Staff Report

To: BOZAR
From: Jessie Earley, Town Planner III
Meeting Date: BOZAR, January 28, 2025
RE: 422 and 422 ½ Sopris Avenue, Final Review

PROJECT TITLE: Breuer Residence (422 Sopris Avenue)

Proposed Site Plan (1/28/2025 BOZAR)

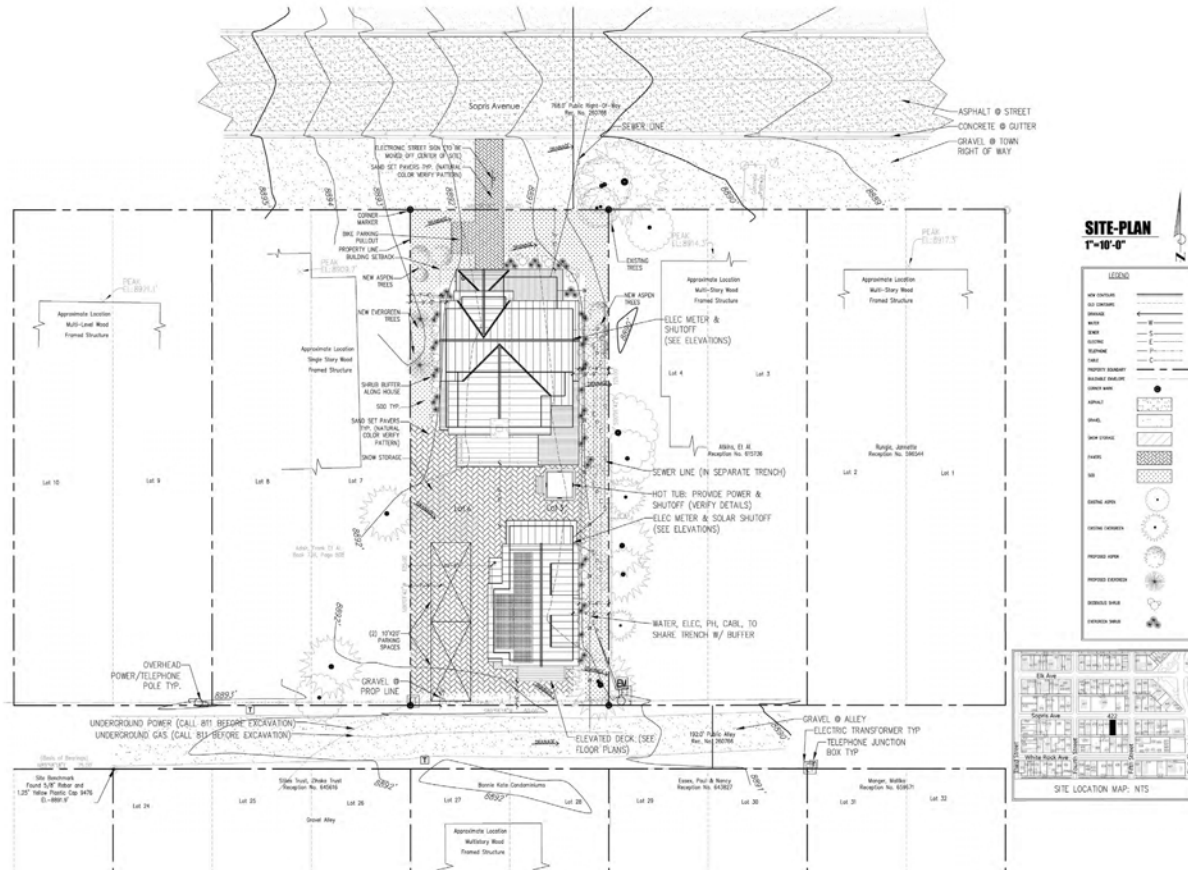
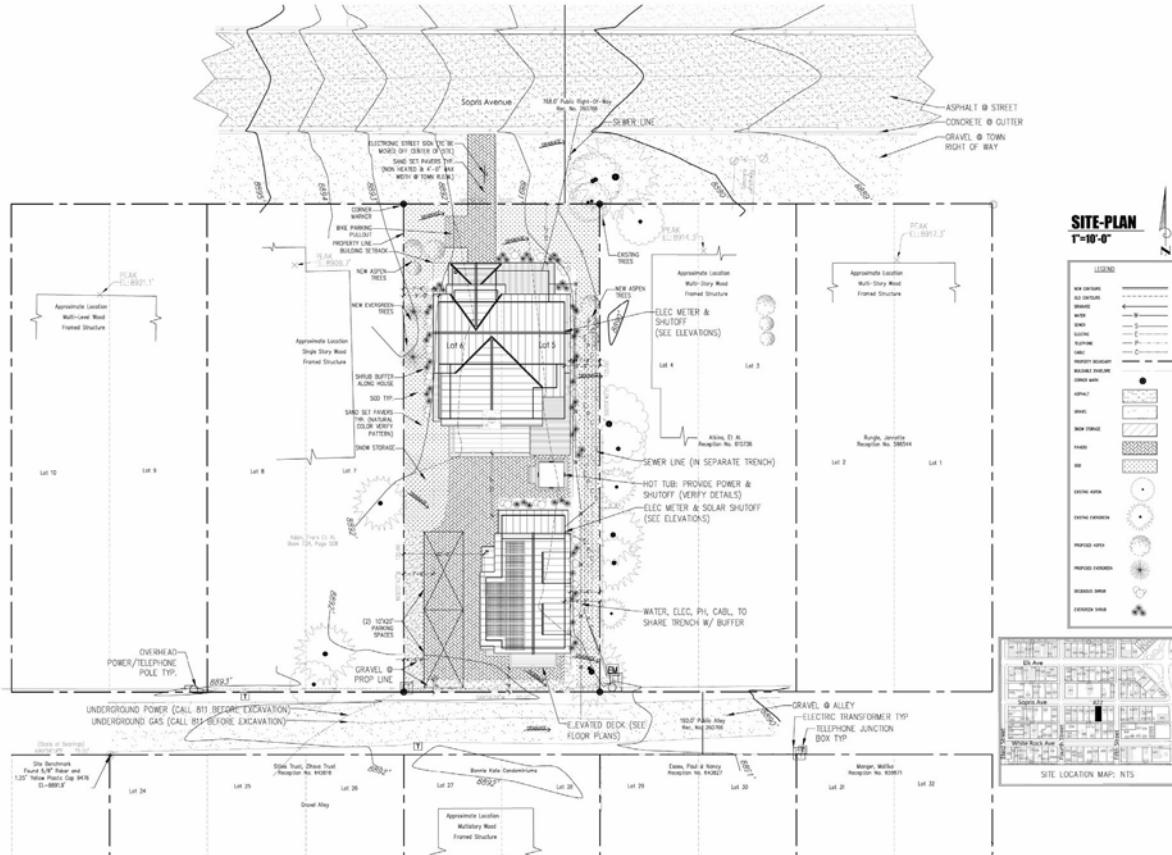
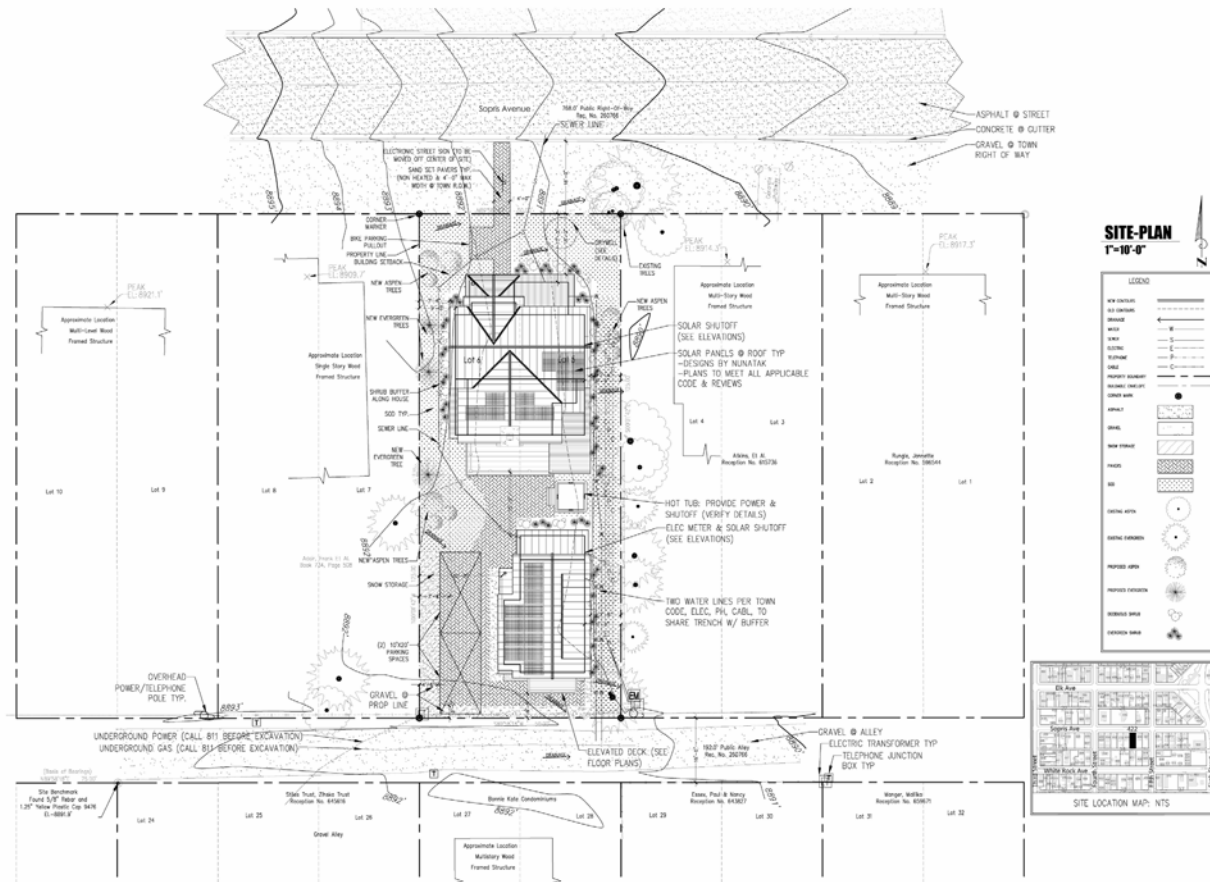
GL	Staff Analysis	DRC Recommendation
Topography	Provided on sheet C1. Slopes down from 8892' to 8891' to the East. For the primary building for the purposes of FAR the natural grade is 8891'6". For the accessory dwelling, the grade for the purposes of FAR would be 8891'6".

2.8 Drainage	<p>Drainage swales are shown for the primary and accessory building to the east. However, drainage will need to be revised to encourage drainage to the alley or the street not the adjacent lot.</p> <p>A dry well is now shown on the north side of the lot. This will need to meet the specifications required by the Public Works Department.</p>	<p>12/9 DRC: Drainage cannot be to the neighboring property. Revisions needed</p> <p>1/13 DRC: Drainage cannot be to the neighboring property. Revisions needed</p>
Easements	NA	NA

2.16 Substantial landscaping	The plan is fairly general. Provision of a final landscape plan can be required, if changes occur.	
2.18 Preservation of existing mature trees	<p>This site is heavily treed. There are smaller existing trees in the middle of the lot that will need to be removed for the placement of the home and accessory. Confirmation of the number and size is required to ensure these are less than the caliper noted within the code 16-15-10.</p> <p>Also, there are trees along the edges of the lot to the west (10) and east (3) and that are noted to be removed and replaced.</p> <p>There are seven trees on the south that are proposed to be removed to ensure access to the new accessory dwelling.</p> <p>It appears that all trees that exist on the lot with the exception of the one spruce tree on the southeast corner will be removed. This is excessive and counter to other proposals the Board has reviewed and GL 2.18 a which speaks to trees within side setbacks. There have been other instances where soil nails were used to retain trees. Staff encourages potential retention of large trees on the east and west, thinning out smaller trees and as many trees to remain as possible. There is a suggested provision in the finding about the applicant hiring an arborist to help evaluate this.</p>	<p>12/9 DRC: Members asked for a more detailed plan for what trees would be removed. This has been provided.</p> <p>1/13 DRC: Members appreciated the tree plan. They asked for the number of trees in the mid lot area and size.</p> <p>The trees on the south were supported for removal due to access for the proposed ADU.</p> <p>The trees on the east and west would be a topic of conversation for the full Board.</p>

2.19 New trees	<p>There are a cluster of new aspen trees (3) on the northwest corner of the lot and new evergreen trees (2) along the west.</p> <p>There is a new aspen and evergreen tree on the southwest corner of the lot.</p> <p>There are three new aspen trees noted on the eastern edge of the lot.</p> <p>Shrub buffers are noted on the west and east of the primary and the east of the ADU.</p>	<p>12/9 DRC: Members asked for a more detailed plan for what trees would be removed. This has been provided.</p> <p>1/13 DRC: Members noted that the existing and proposed trees would be a point of discussion for the full Board.</p>

2.16 a./ 2.20 Native plantings	Sod is noted on the north portion of the property and on the east side of the structures. Generally, the GL supports use of native grasses. Discussion is encouraged.

2.16 e Pervious materials	<p>There is a small area of gravel on the south side of the lot adjacent to the alley.</p> <p>The south portion of the lot and between buildings is called out as sand set pavers and was reduced from (2125.07 sf – 12/9 DRC) to (1286.35 sf -1/13 DRC) to (1105 sf). It is appreciated that the material is pervious.</p> <p>There is a walkway and bike parking pull out on the north side of the lot, which extends into the right of way that is also noted as sand set pavers (274.76 sf). The width of the sidewalk on the north has been revised and does not exceed 4' into the ROW and cannot be heated.</p>	<p>12/9 DRC: Members expressed concerns regarding the amount of hardscape on the south. This was revised.</p> <p>1/13 DRC: The revisions were more well received. However, there was still a concern from one member about the amount of hardscape proposed. This has been further reduced.</p>

2.28 e & f Parking substrate	Parking spaces are noted as sand set pavers, which meet the intents of the GL. General support.	Support
(2.37-2.40)/ 16-17-40 Exterior Lighting	Proposed lighting appears to comply with night sky requirements. General support.	Support
Solar	There is solar proposed for the west roof face of the ADU, which meets the intents of the GL.	Support
Utilities	<p>Wet and dry utilities have been included on the site plan. Water and sewer lines should not be located on the same side of the home (east), and the plans have been updated to separate these. It now shows wastewater on the west and water on the east.</p> <p>If a lift station is required, it would need to be included on the interior of the structure. This has been noted by the applicant.</p> <p>Adjacent rights of way are included to scale.</p>

2.7 Snow Storage	Snow storage is provided onsite and is over the minimum of 33%. The areas correspond with areas to be plowed.	Support

- Site Plan:
 - Pavers further reduced by:
 - Adding gravel at the garage dripline.
 - Reducing the South West patio & adding grass.
 - Removing the pavers under the Hot Tub & surrounding its concrete pad with grass.

- Limited the entire length of the North walkway to 4'-0" wide.
 - Additional Evergreen & Aspen trees have been added to the South West yard, formerly the patio.

- Drywell Added.
 - Sewer & Water Lines Separated.
 - Two water lines shown by code.
 - Right Of Way dimensions and additional Building Departments notes added, see Astrid's initial review response.

- Note that further discussion of drainage impacts including the possibility of adding swails is expected with town staff going forward.
 - Note: The neighbors at Lot 4 (EAST) have flagged some trees that they would like to see saved. We are cognizant of their wishes & will do everything we can to save them.

Proposed 3D – 1/13 DRC

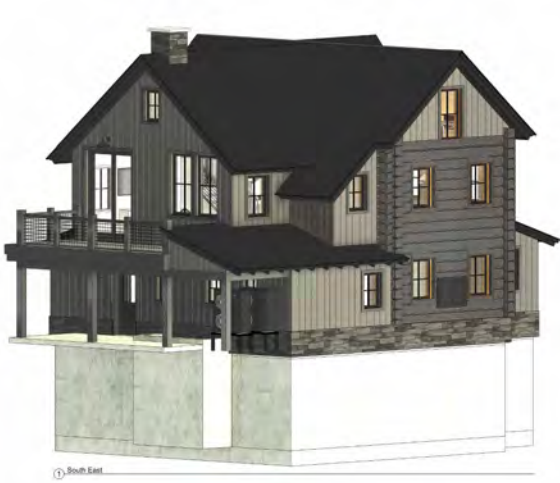
GL	Staff Analysis	DRC Recommendation
4.32-4.33	<p>Consideration of whether the forms achieve relationships with historic buildings are in GL 4.32-4.34. The 3D drawings are helpful in the review.</p> <p>GL 4.32 conveys that new infill construction should relate with the predominate scale of historic neighborhoods. It appears that the</p>	<p>12/9 DRC: Members requested a streetscape to better evaluate mass/scale and form as it relates to the context of the neighborhood.</p> <p>1/13 DRC: Members had concerns regarding mass/scale/form as seen from the street per GL 4.32 a. One member felt that they could support, as drawn,</p>

<p>proposed primary structure may not relate to the scale of the surrounding neighborhood. A streetscape has been provided to assess this, but it appears that the spacing and height may be somewhat askew. 3D massing for streetscapes have been provided for other projects, which may be necessary. This building is at the height maximum of 28' and below the width maximum of 32' per zoning requirements, but the perceived mass may be conflicting with the historic scale of the RIC zone. The design goals of this zone district encourage infill to help preserve the character of the existing buildings. Discussion is encouraged to determine if revisions are required.</p> <p>Per GL 4.33, a diversity of forms is encouraged. Many of the homes on this south side of the block have a gable facing the street. The gable running parallel to the street varies this appearance.</p>	<p>but gave a suggestion to revise materials to help make the building less complicated. Siding materials have been revised in color.</p>

4.34 Discernable primary module	<p>The middle parallel module meets this requirement.</p> <p>This module is also the largest in relation to height and width.</p>	Support

- House:
 - We have reduced the building height 2" to comply with the height limits.
 - Added a confirming 12" dimension to the Westerly stairwell windows & building corner.

- Changed the Brown siding to Grey to match the log siding. This was changed in response to BOZAR discussion & the thought that multiple color siding was too much contrast for this zone.

Rear porch (1/28/2025 BOZAR)

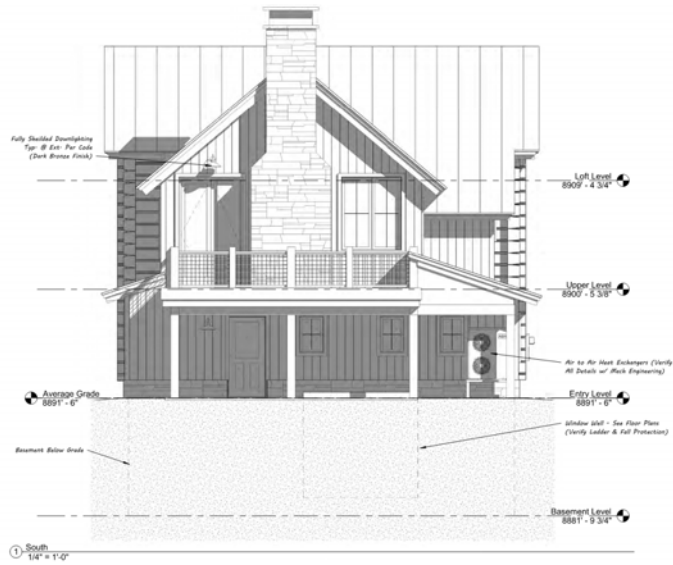
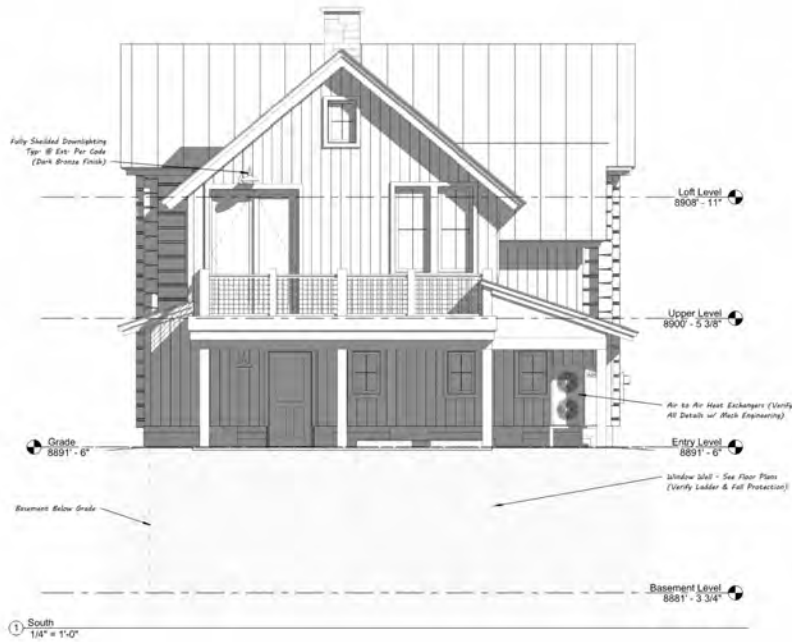
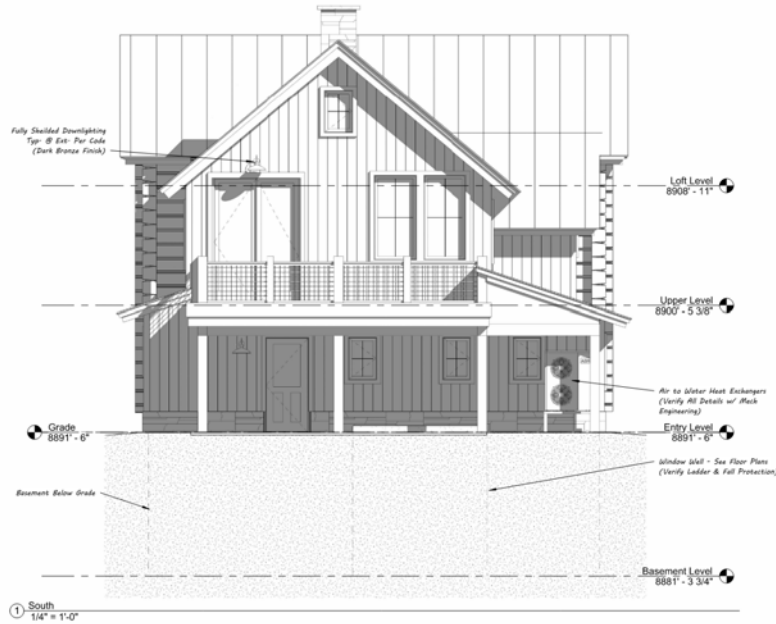
4.49/5.118 Primary entrance porch	These GL encourage clearly defining the entry, which is done in many cases with a porch as seen on many historic buildings and also on this building. General support.	Support
4.50 Mix of porch sizes	The front porch is 8'x10'6", which meets the intents of this GL.	Support
4.51 Rear entry porch	The porch on the rear is simpler with the shed than the front porch, as asked for in GL 4.51.	Support

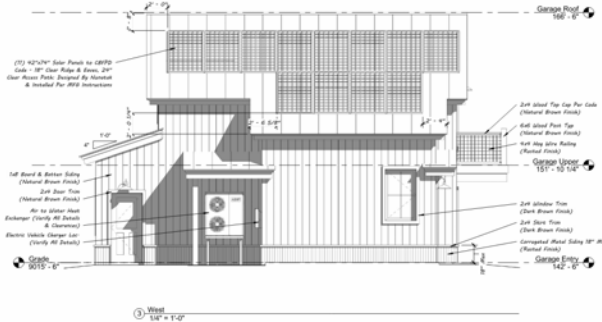
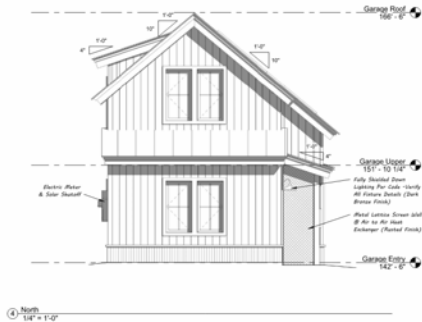
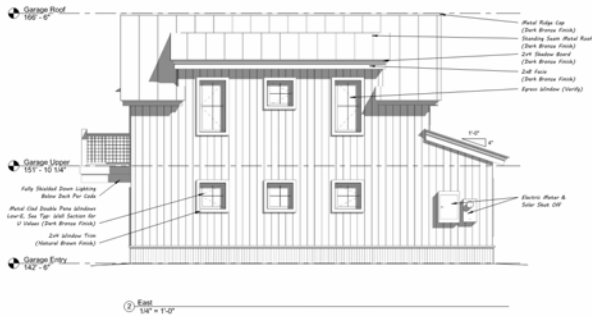
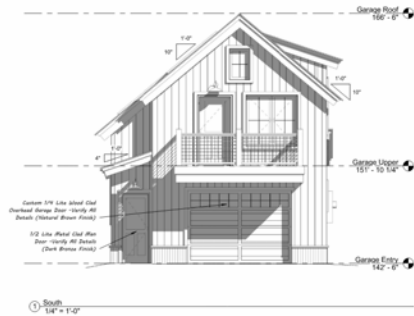
GL	Staff Analysis	DRC Recommendation
4.85 Placement	The building is set to the rear of the site.	Support
2.30/ 4.84 Mass/scale/form	<p>The building is simple in form with a gable facing the alley. General support.</p> <p>The Board can determine if an alleyscape would be of help to assess this.</p>	Support
4.86 Vary appearance	This building will vary in appearance from other buildings on this portion of the block.	Support
4.87 ADU Mass/scale/form	The one large, eyebrow dormer/roof element, as proposed on the east appears to conflict with GL 4.46-4.48. The Board has seen similar proposals on a few ADU's and discussion is encouraged. If the Board members	<p>12/9 DRC: Members suggested simplification of the two proposed elements on the east. This has been revised to one.</p> <p>1/13 DRC: Members felt that although</p>

<p>consider this a dormer, this is reviewed below.</p> <p>GL 4.87 b allows dormers to break the eave if the height is 3' below maximum, but this is at the height maximum at 24'.</p>	they understand the purpose and value the feature was in fact a dormer due to the application of GL 4.47 b.

2.30 b/4.88 Mass/scale/form	This building has a gabled ridge (10:12) running north to south with a shed module on the north (4:12). The 3D perspectives are helpful to visualize this building within the neighborhood context.	Support

4.89 d Decks	This deck is located in the rear and is not highly visible. Support.	Support
4.53/4.89 e Fenestration	<p>The south elevation proposes fenestration in the garage door and person door on the first floor and a two pack of windows and door glazing on the second floor with a small window in the gable.</p> <p>The east elevation proposes three small square windows on the first floor and three windows on the second floor.</p> <p>The west elevation proposes one single window and door glazing on the first floor.</p> <p>The north elevation proposes a two pack on the first floor and a two pack on the second floor.</p> <p>Windows are proposed as casements. Similar to the discussion above for the primary residence per GL 4.54. Double hungs would be encouraged unless needed for egress.</p> <p>Two packs of windows must have 3.5" of trim and cannot be mulled. It appears that this has been met with the 6" provided on the north. However, the two windows on the south must be revised.</p>	Support

4.41-4.45 Roof Forms	The 10:12 roof pitches are consistent with the existing roof pitch on the main house.	Support
4.64-4.66 Doors	<p>There are three half-light person, metal clad doors on the south and west (dark bronze). Support.</p> <p>The garage door is proposed with a wood veneer (natural brown). Support.</p>	Support

GL	Staff Analysis	DRC Recommendation
4.46 Dormers in new construction	There is a roof element proposed for the east elevation. Discussion is needed to determine if the Board considers this a dormer. If so, it is a shed dormer, which is supported by this GL. .	1/13 DRC: Members expressed that this is a dormer.

4.47 Dormers	<p>The dormer steps down 1'9" from the ridge of the garage module and achieves subordination.</p> <p>a. If viewed as a dormer, as proposed it occupies 50.8% of the roof.</p> <p>b. The dormer is lower than the ridge. There is not a section of roof beneath, as required in core zones.</p> <p>c. If viewed as a dormer, as proposed it occupies 50.8% of the roof.</p> <p>d. The proposed element extends past the middle third on both the south and north sides.</p> <p>e. Met.</p>	<p>1/13 DRC: Members expressed that this was a dormer due to the language in 4.47 b. requiring it in core zones.</p> <p>With that in mind, it doesn't comply with GL noted.</p>

4.87 Dormers on ADU	4.87 b. See above. c. If considered a dormer, this breaks the eave line and isn't less than 3' than 24'. d. NA	
---------------------	--	--

- Accessory / Garage:
 - Removed the corrugated metal siding from the stair module & replaced it w/ siding & metal skirt to match.
 - Unified the separate dormers into a single "Roof Element". Also adding a window to the center of the space.
